SUBJECT: SEP TOPICS II-1.A, "EXCLUSION AREA AUTHORITY AND CONTROL"
AND II-1.B, "POPULATION DISTRIBUTION (DRESDEN 2)"

DRESDEN UNIT 2

TOPIC II-1.A, EXCLUSION AREA AUTHORITY AND CONTROL

TOPIC II-1.B, POPULATION DISTRIBUTION

Figure 2.2.1 Station Property Plan

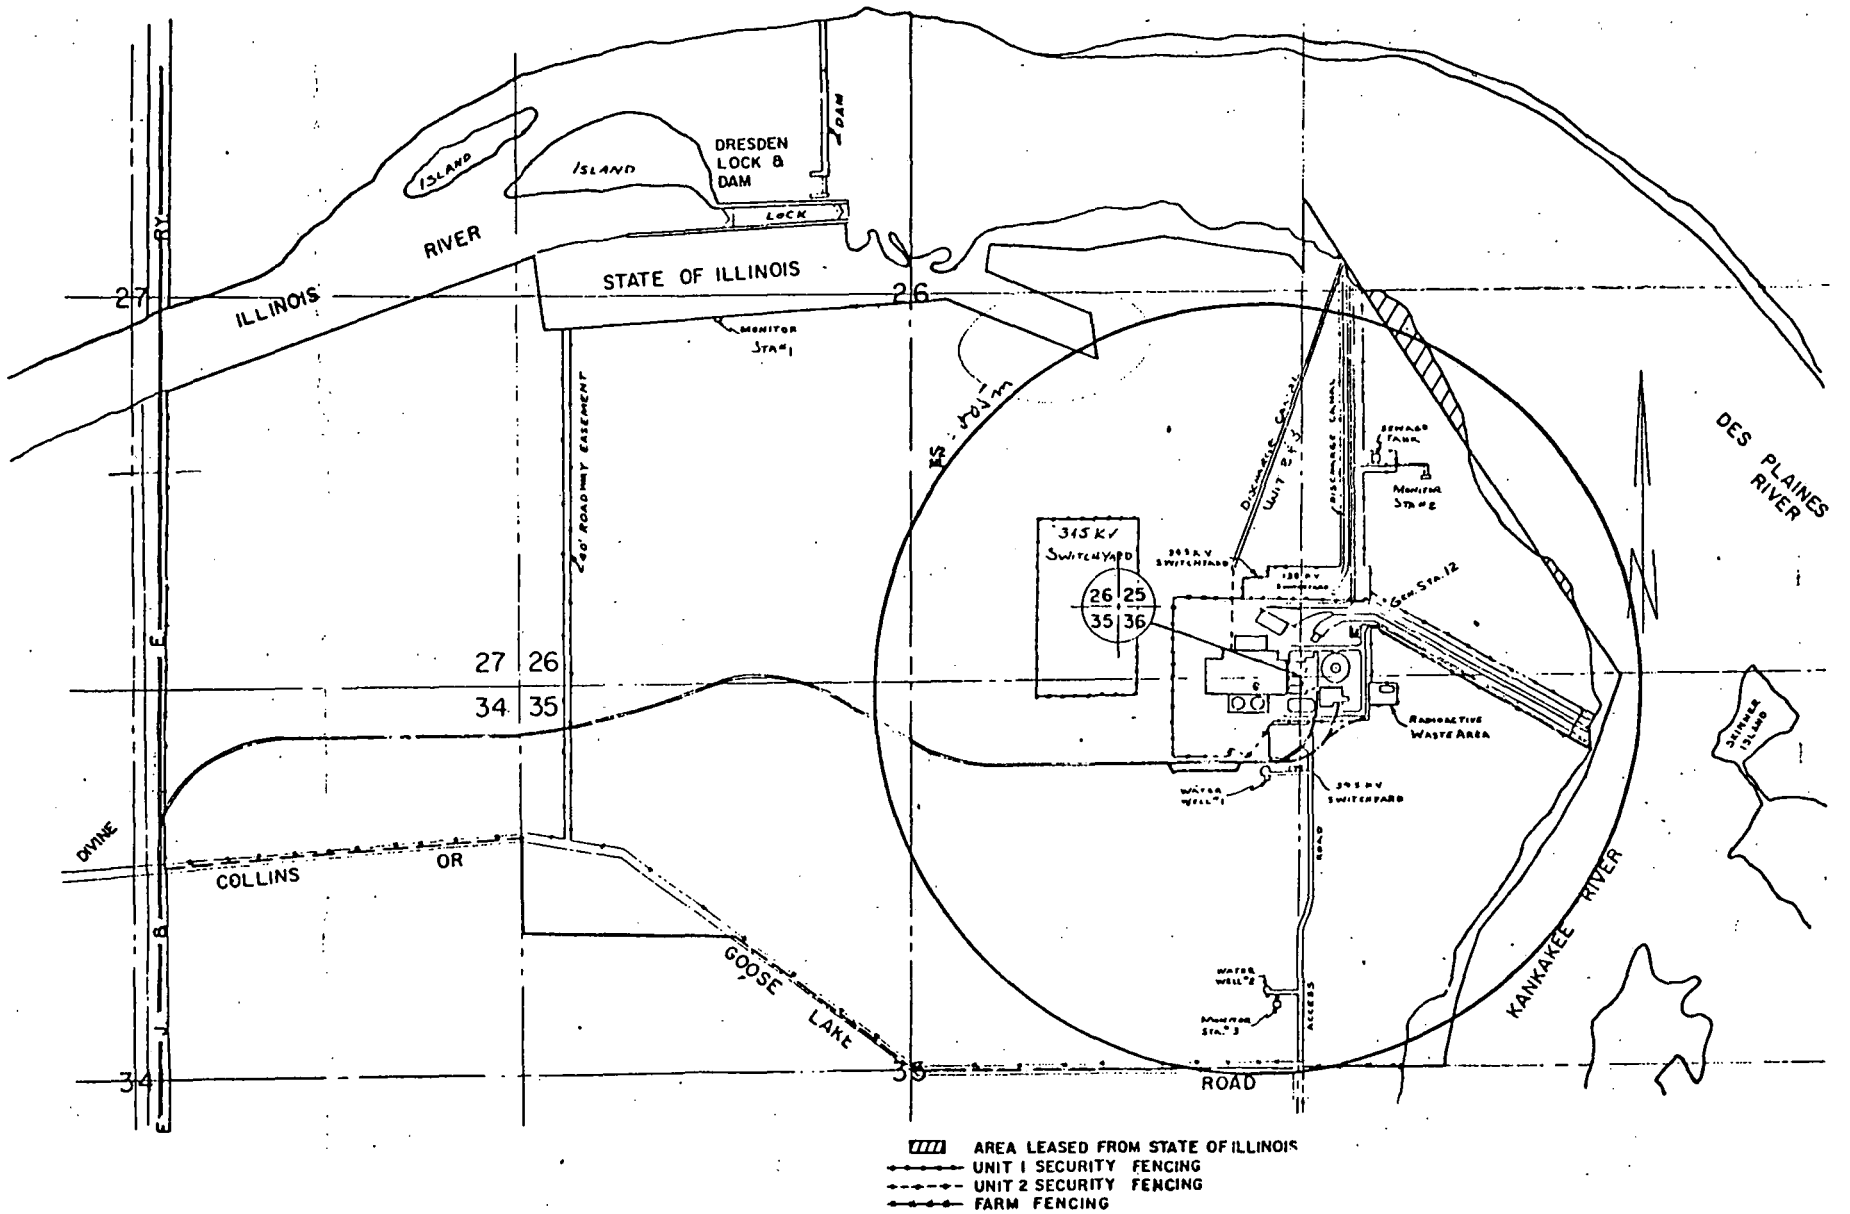
The Dresden Nuclear Generating Station is located in Goose Lake Township, Grundy County in the State of Illinois. The plant site is approximately 14 miles southwest of the city of Joliet, Illinois and 25 miles south of Aurora, Illinois. The site property comprises approximately 953 acres, with approximately 450 acres leased to a neighboring farmer for cattle grazing and field crops. The lease has been modified with a clause which allows Commonwealth Edison to have "sole authority to determine the right of access and the right to be present in the area covered by this lease" when the Generating Station Emergency Plan (GSEP) is in effect. In addition to Unit 2, Unit 1 and 3 also occupy part of the site. No public highways or railroads transverse the exclusion area. The exclusion area and principle plant structures are shown in attached Figure 2.2.1, which is a common exclusion area for all three nuclear units.

The exclusion area radius of 800 meters is defined in Section 1.2 of the Commonwealth Edison-GSEP (3). Through direct ownership including mineral rights or a lease agreement with the State of Illinois the licensee has total control of the entire exclusion area with the exception of control over the Des Plaines and Kankakee Rivers. As a result, arrangements have been made through ESDA and DNS with the U.S. Coast Guard and documented in the Commonwealth Edison Generating Station Emergency Plan (4) for the control of the water traffic in event of a plant emergency.
